Piper Aircraft Corporation
Vero Beach, Florida, U.S.A.

SERVICE *No.* 923 BULLETIN

Date August 16, 1989 M

Main Landing Gear Actuator
Reinforcement Bracket Replacement

Sketch "A"

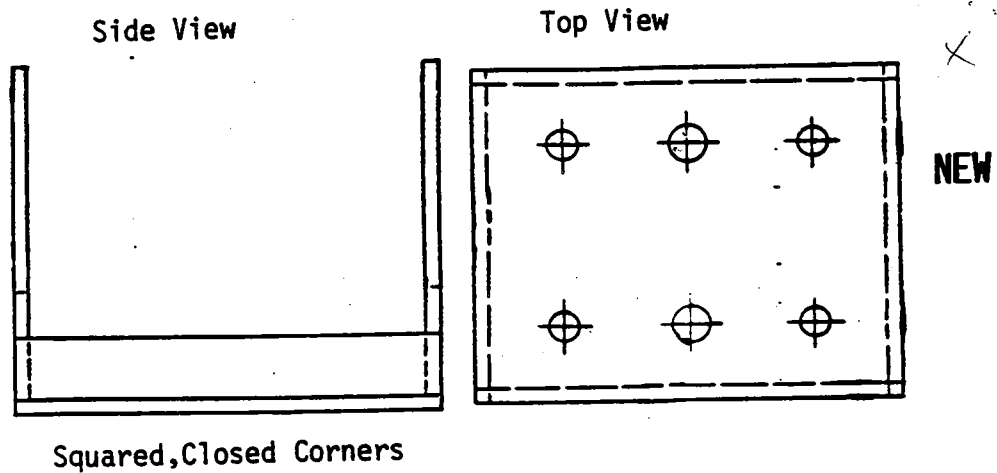
Some aircraft may have the new actuator reinforcement brackets (Piper Part Number 73786-02) installed as replacement parts. Refer to Sketch "A" for identification of Piper Part Numbers 40776-00 (old) and 73786-02 (new). Aircraft with Piper Part Number 73786-02 installed on both sides are in compliance with this Service Bulletin.

Sketch "B"

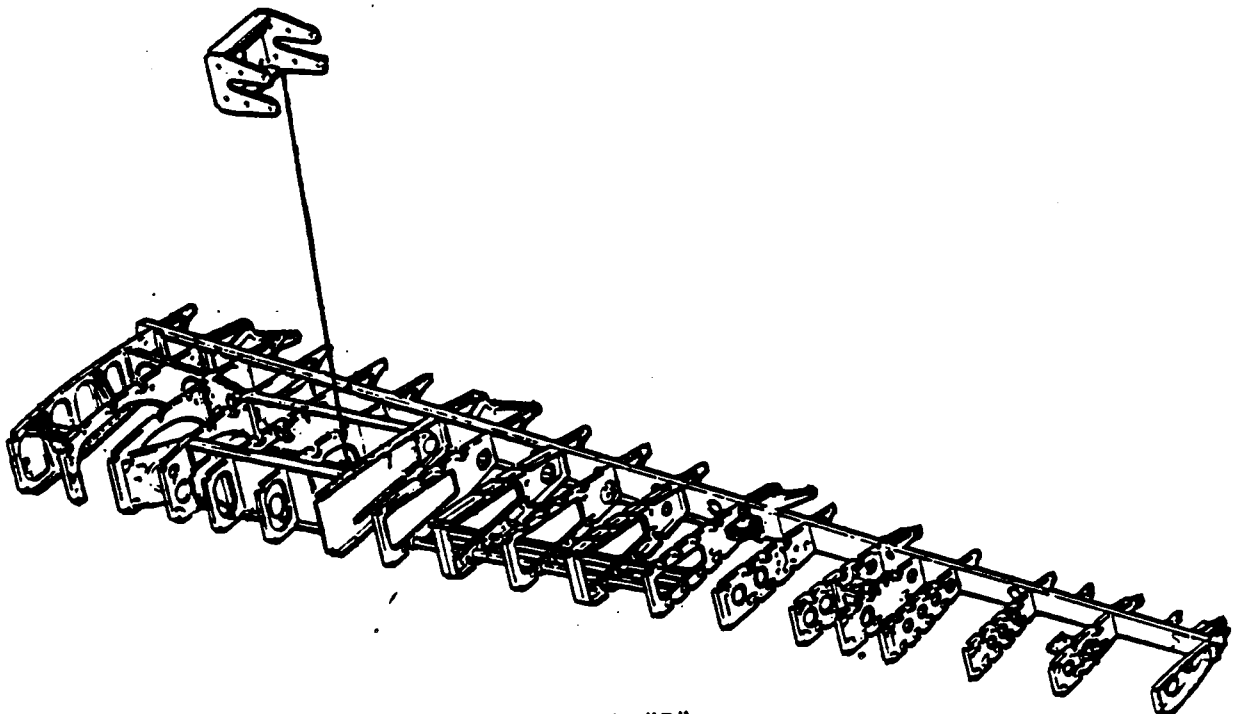
1. Place aircraft on jacks.
2. Locate the main landing gear actuator reinforcement bracket on the left and right wings. See Sketch "B" (attached).
3. Remove and discard original Actuator Reinforcement Brackets, Piper Part Number 40776-00. Install Piper Part Number 73786-02, as shown in Sketch "C".
4. Inspect and perform gear retraction per appropriate Chapter in the Maintenance Manual.
5. Remove aircraft from jacks.
6. Make appropriate logbook entry of compliance with this Service Bulletin.
